REVIEW OF PERMIT APPLICATION RMU-2, CWM MODEL CITY

**Anirban De, Ph.D., P.E.
Professional Engineer
New York License No. 080871**

Project Number: 1303
15 October 2014

(“Thickness Contours of Galciolacustrine Clay Unit”,
included as Attachment B, in Appendix C-4 of the Engineering Report)

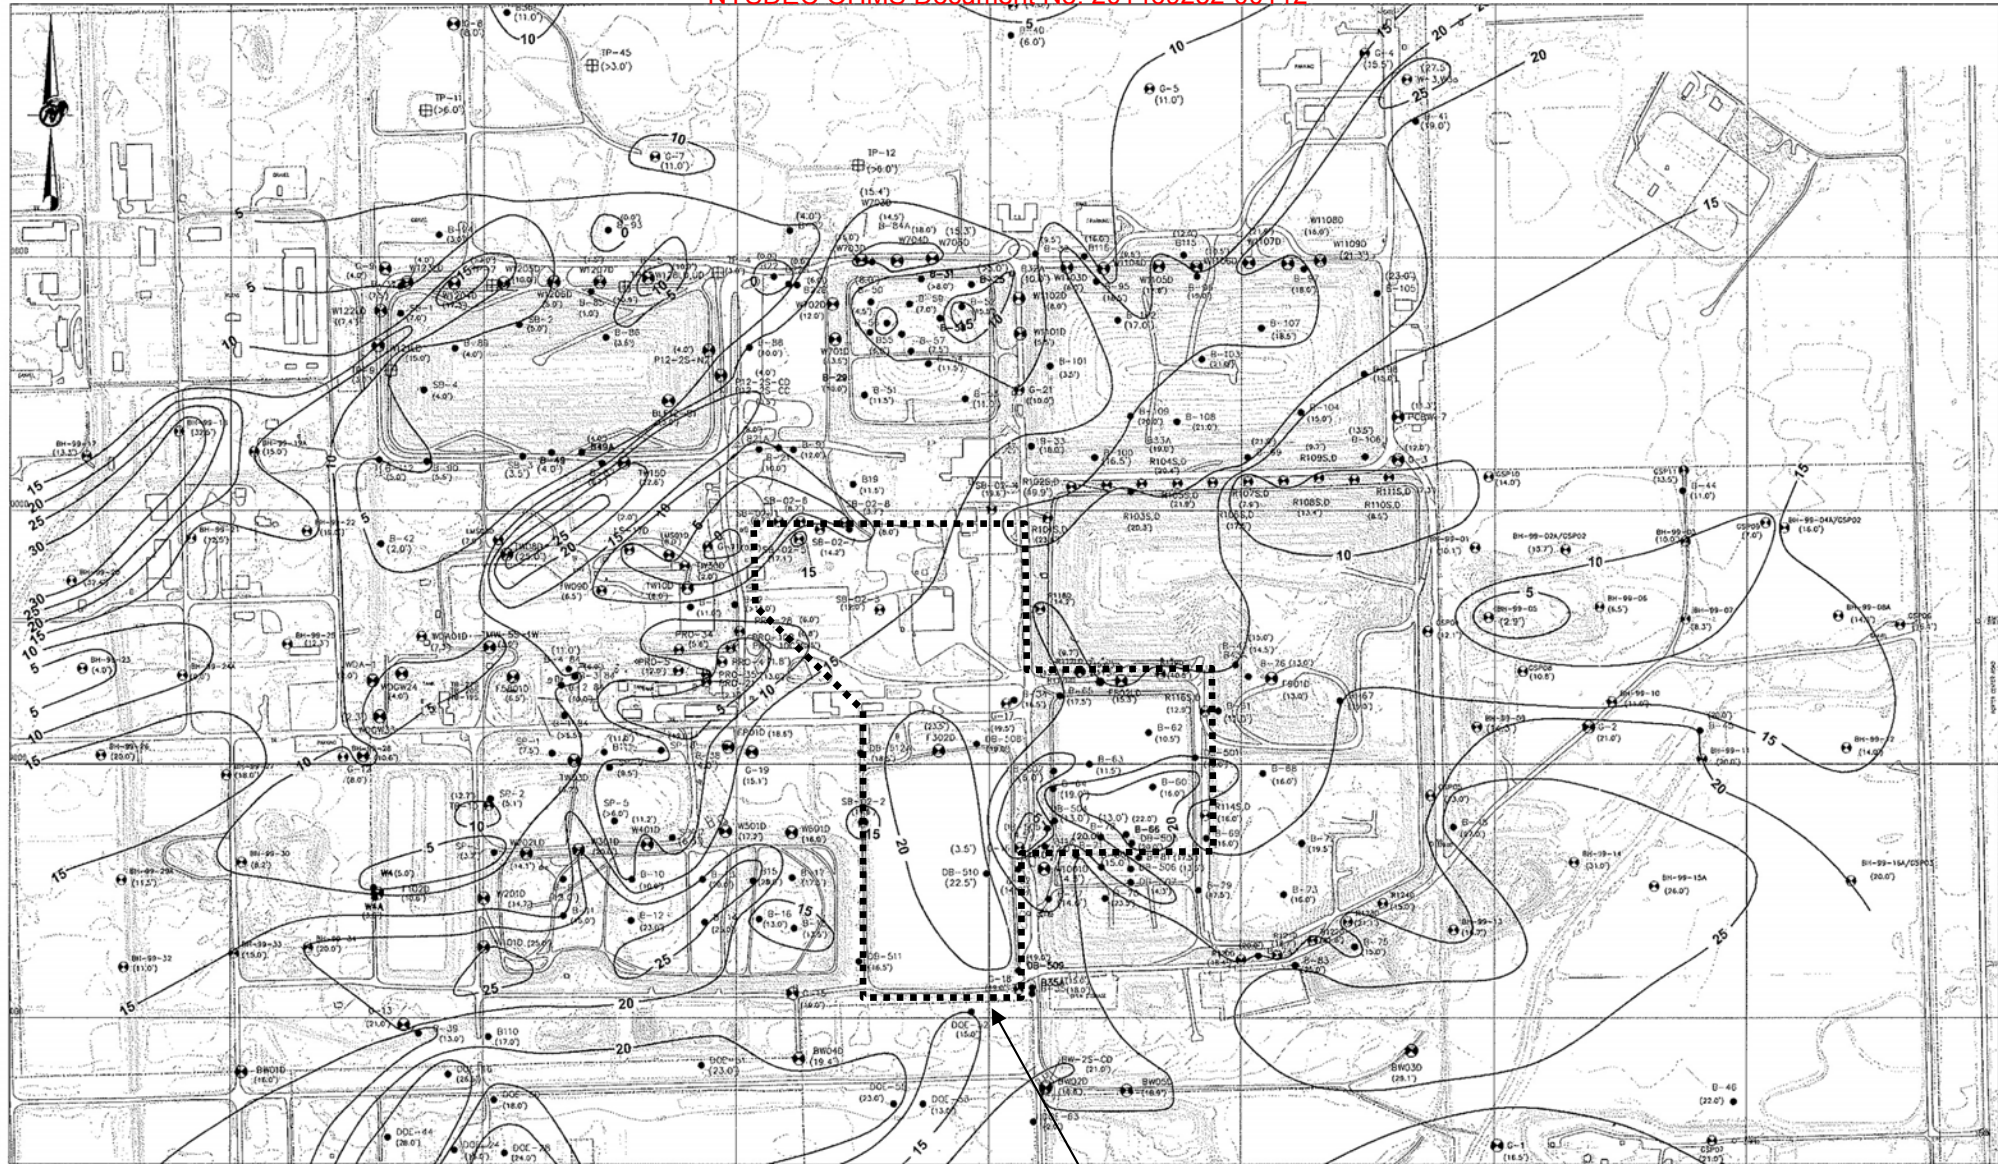
- A drawing titled “Thickness Contours of Glaciolacustrine Clay Unit”, included as Attachment B, in Appendix C-4 of the Engineering Report (Exhibit A)
- A drawing titled “Thickness of Glaciolacustrine Clay”, included as Figure 9 of the 2013 Hydrogeologic Characterization Update (Exhibit B)
- Section 2.2.1 Site Geology of the Engineering Report

Despite having almost identical titles, Exhibits A and B present contours of GC unit thickness that are not the same. However, contours shown in both figures indicate that the thickness of the GC unit is less than 5 feet in some areas below the proposed RMU-2 footprint.

GC unit thickness of between 11 ft and 21 ft in various cells of RMU-2 is used in the applicant’s hydrostatic uplift analysis (Table 1 of Appendix C-4 of the Engineering Report). A 2002 figure of thickness contours by Golder Associates (Exhibit A) is cited as the source of this information. However, thickness contours shown on a more recent drawing by Golder Associates (Hydrogeologic Characterization Update, 2014), included here as Exhibit B, are quite different from those shown in Exhibit A. According to Exhibit B, there are significant areas within RMU-2 where the thickness of the GC unit is 5 ft or less (e.g., near sumps of Cells 15 and 16 on the north part and near sump of Cell 18 on the west part).

(“Top of Glaciolacustrine Clay Unit Contours”
included as Attachment A to Appendix C-4 of the 2013 Engineering Report)

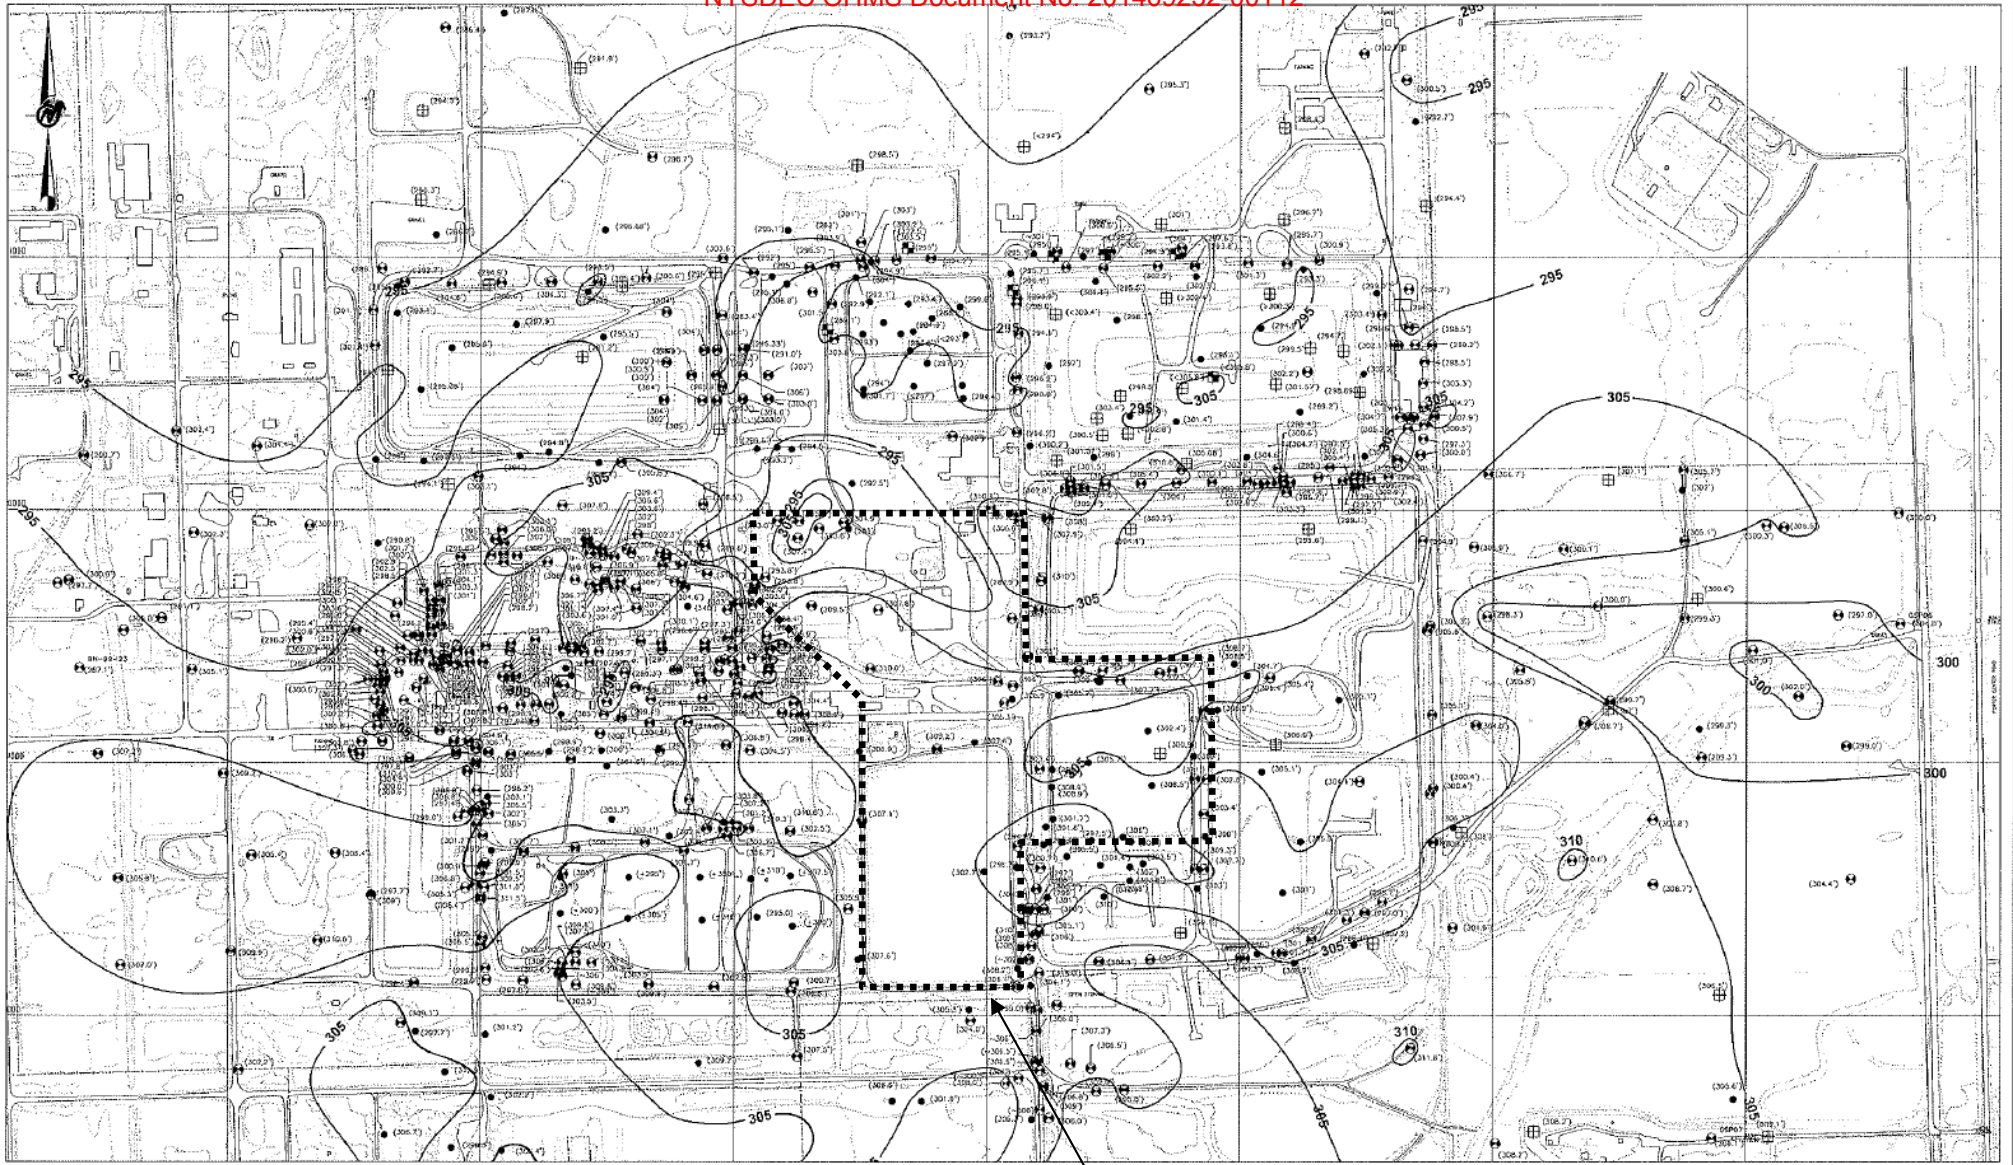
As part of the hydrostatic uplift analysis (Table 1 of Appendix C-4 of the Engineering Report), the applicant has shown the top of the GC unit to be at elevations of 293 ft and 295 ft amsl in Cells 15 and 16, respectively. A 2002 figure of top of GC elevation contours by Golder Associates (Exhibit C) is cited as the source of this information. However, elevation contours shown on a more recent (2014) drawing by Golder Associates (Exhibit D) are quite different from those shown in Exhibit C. According to Exhibit D, the elevation of the top of GC unit is between 303 ft and 310 ft amsl, in the north parts of Cells 15 and 16 (where the sumps are located), with most areas having an elevation of about 307 ft amsl.

(“Top of Glaciolacustrine Clay”
included as Figure 10 of the 2013 Hydrogeologic Characterization Update)

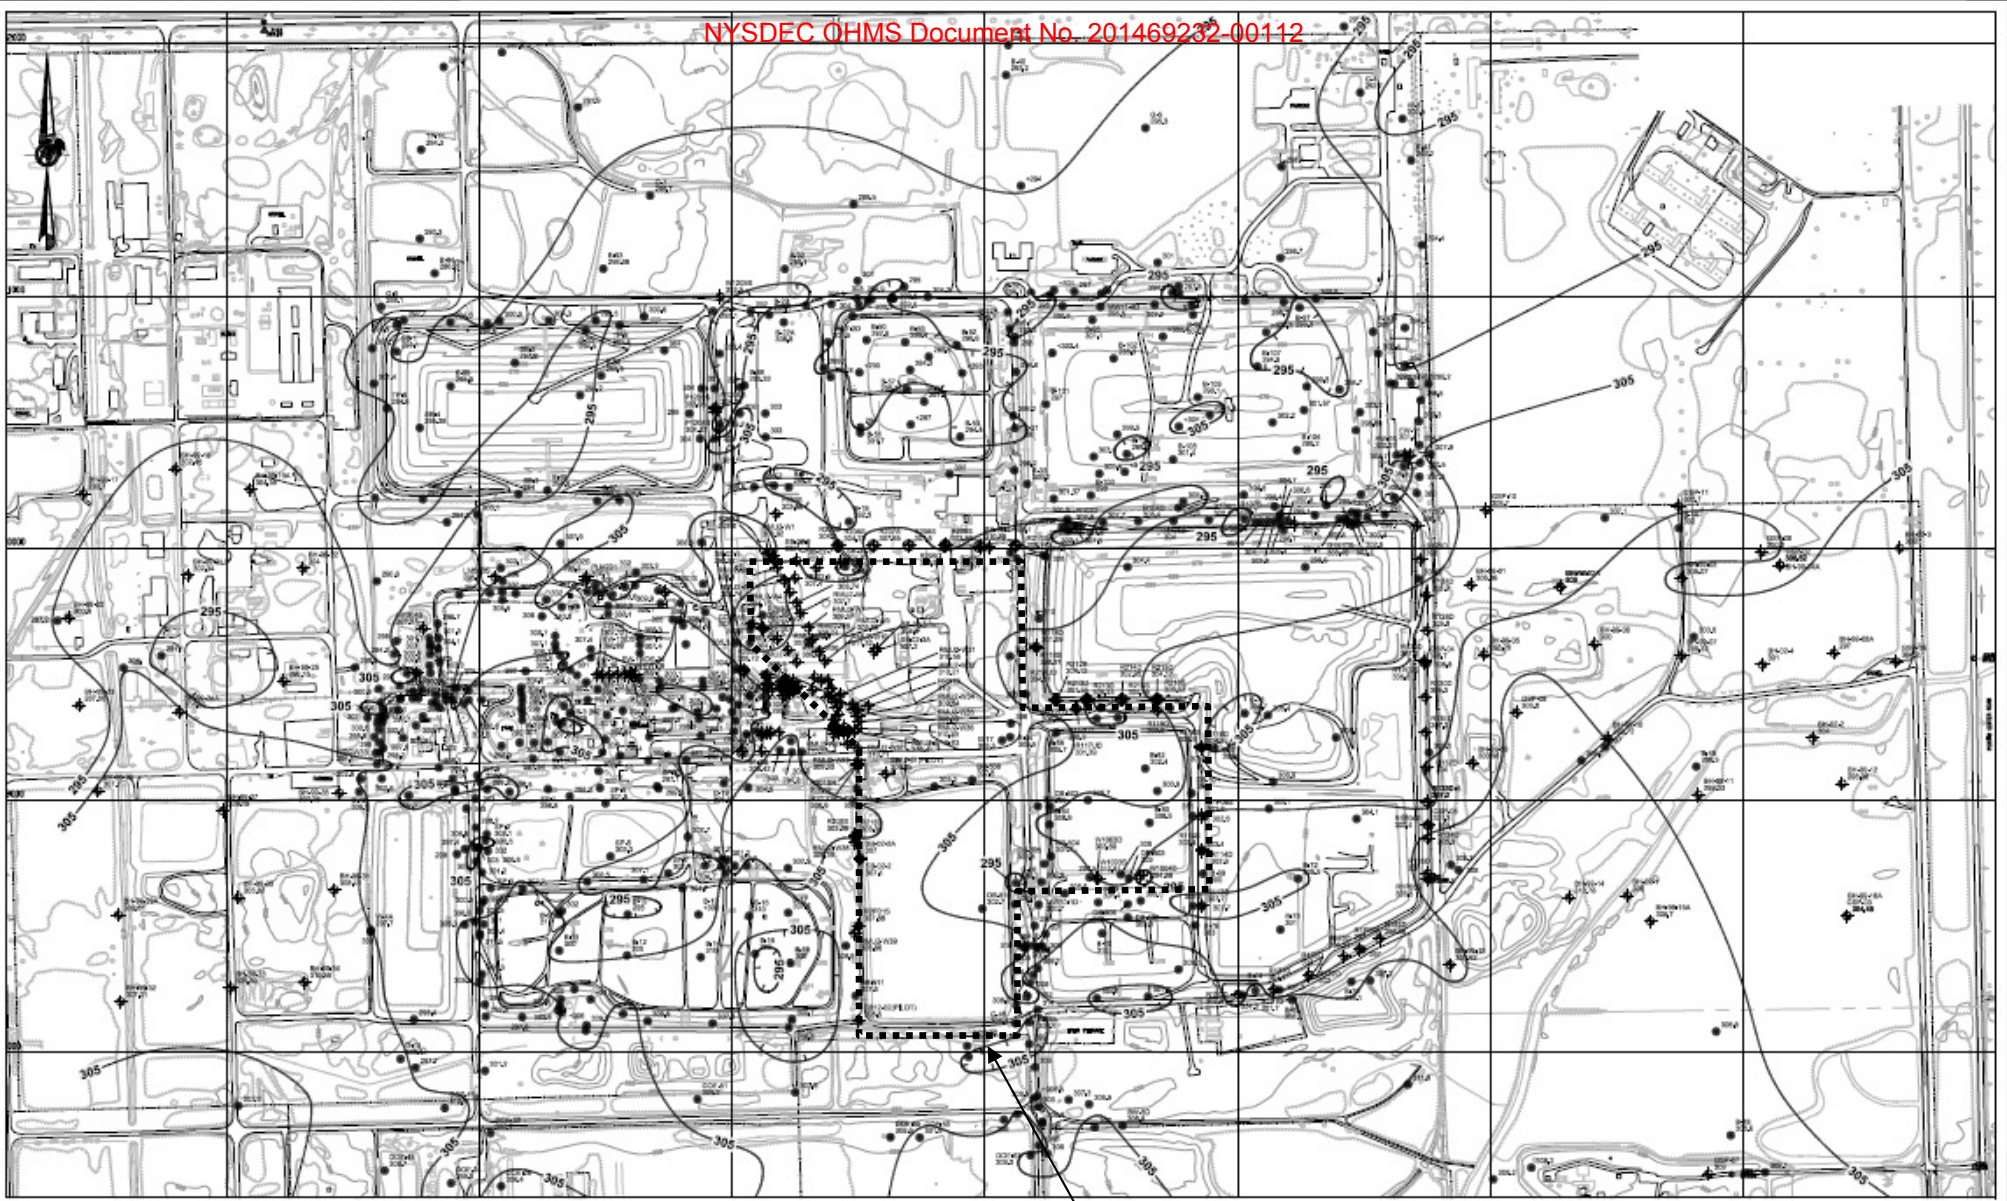
According to most recent drawings by Golder Associates, as part of Hydrogeologic Characterization Update (2014), the top of the GC unit is at an elevation of about 307 ft and the unit is about 5 ft thick in the area where the sumps of Cells 15 and 16 are to be located. According to Table 2 in Appendix C-4 of the Engineering Report, the lowest elevations of sumps in Cells 15 and 16 are to be 298.5 ft and 296.6 ft amsl, respectively.

(“Thickness Contours of Glaciolacustrine Silt/Sand Unit”,
included as Attachment 1 of Appendix A-1 of the Engineering Report)

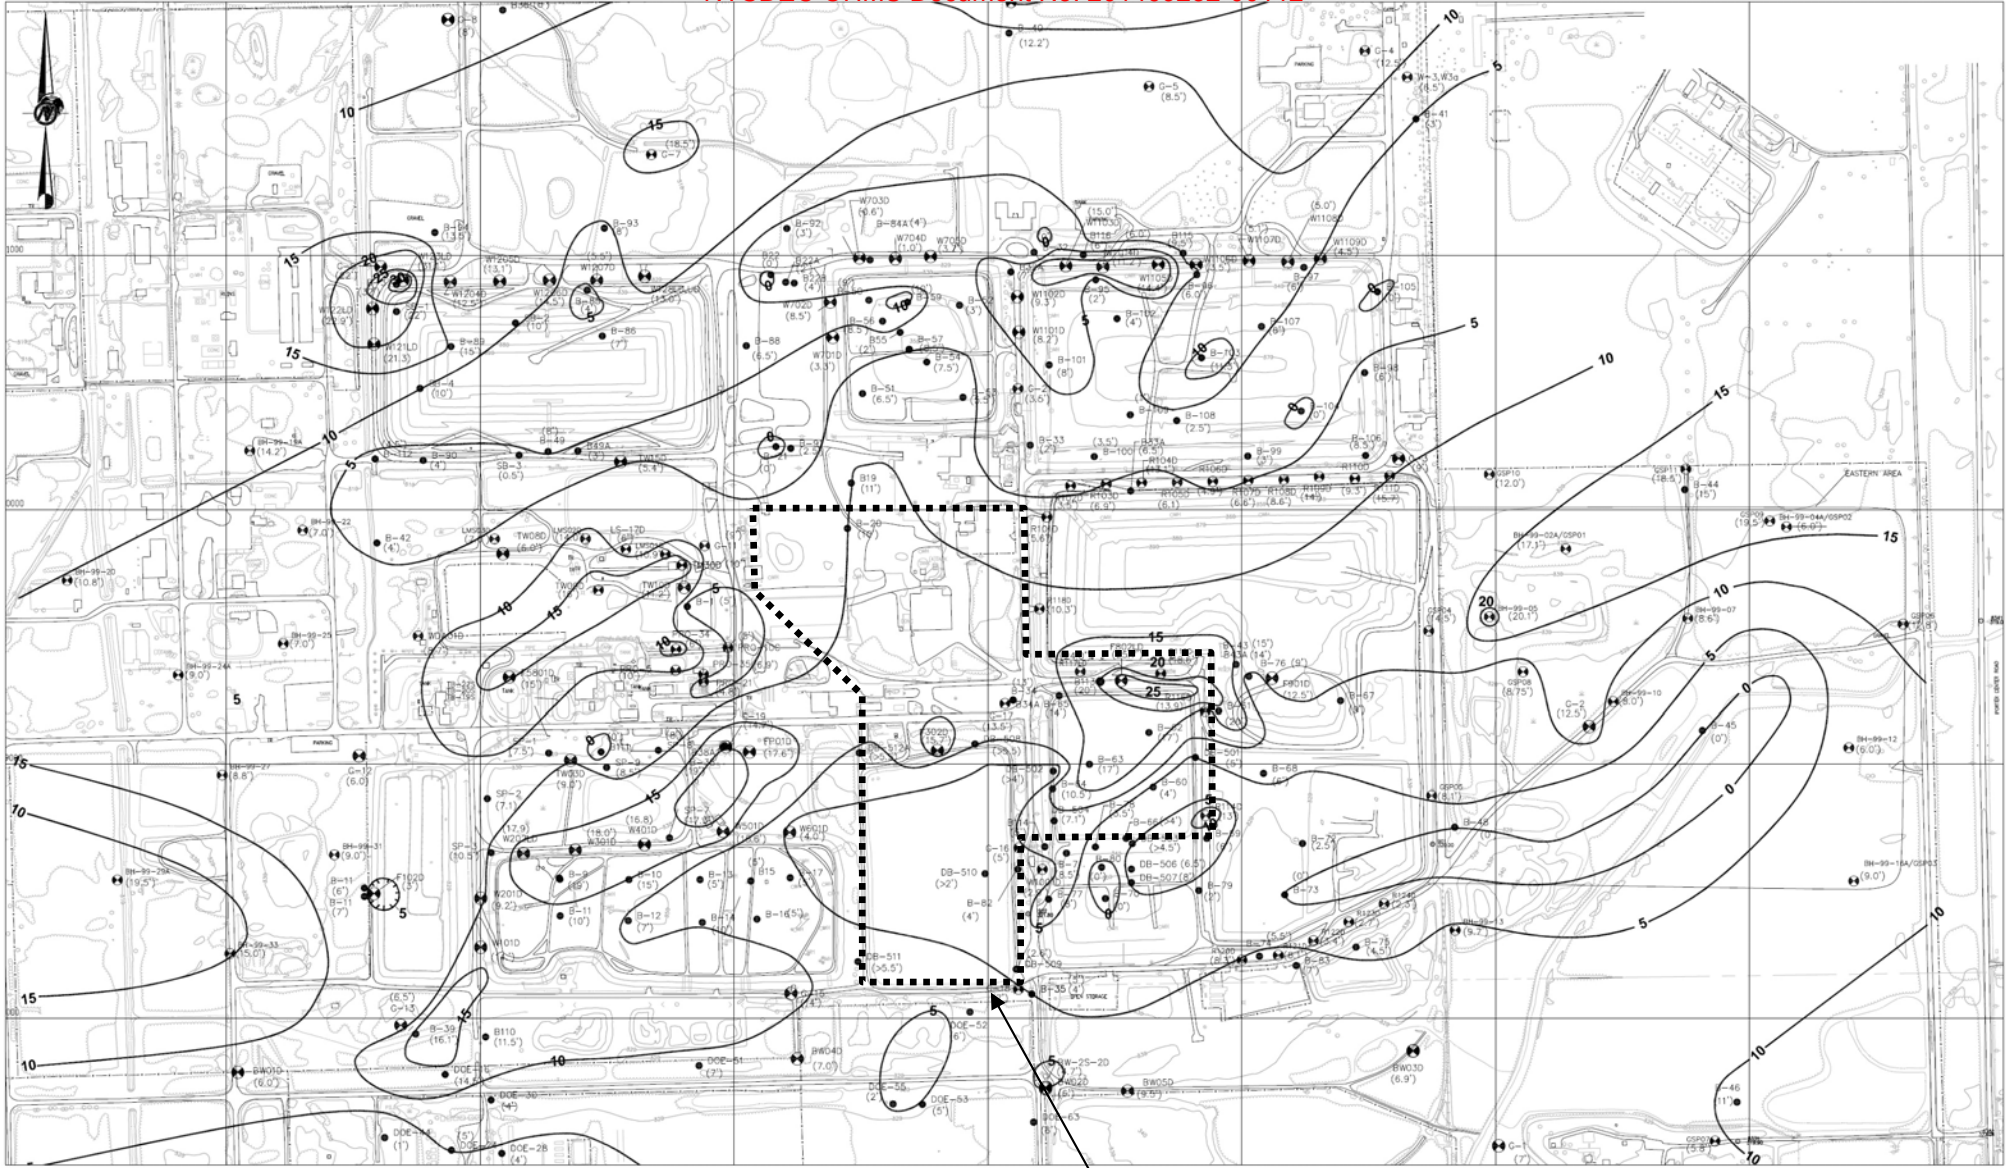
Attachment 1 of Appendix A-1 presents the “Thickness Contours of Glaciolacustrine Silt/Sand Unit” (Exhibit E). According to this drawing, the thickness of the GSS unit varies from 25 feet to less than 5 feet within the footprint of the proposed RMU-2 landfill. Thickness contours shown in Exhibit E are not consistent with those from a more recent drawing by Golder Associates (Hydrogeologic Characterization Update, 2014), included here as Exhibit F.

The figure referred to in the last sentence is included here as Exhibit E (“Thickness contours of Glaciolacustrine Silt/Sand Unit”).

A review of Exhibits E and F indicates a general lack of borings under the proposed RMU-2 footprint. There are only a few contour lines through the footprint area, connecting points that are very far apart. This is especially true for the western portion of the site. Thus, the applicant has relied on borings outside the RMU-2 footprint and interpolation over large distances to calculate presumed thickness of the GSS unit.

The applicant must conduct a thorough soil boring program covering the footprint of RMU-2 to establish the hydraulic conductivity and thickness at different locations of the GSS unit, without having to rely on large-scale interpolation. Based on the results, the applicant may consider an underdrain system specifically engineered to dissipate excess pore water pressure during consolidation. In that event, the applicant must take into account the possible impacts of such an underdrain on the localized hydrologic conditions at the site.
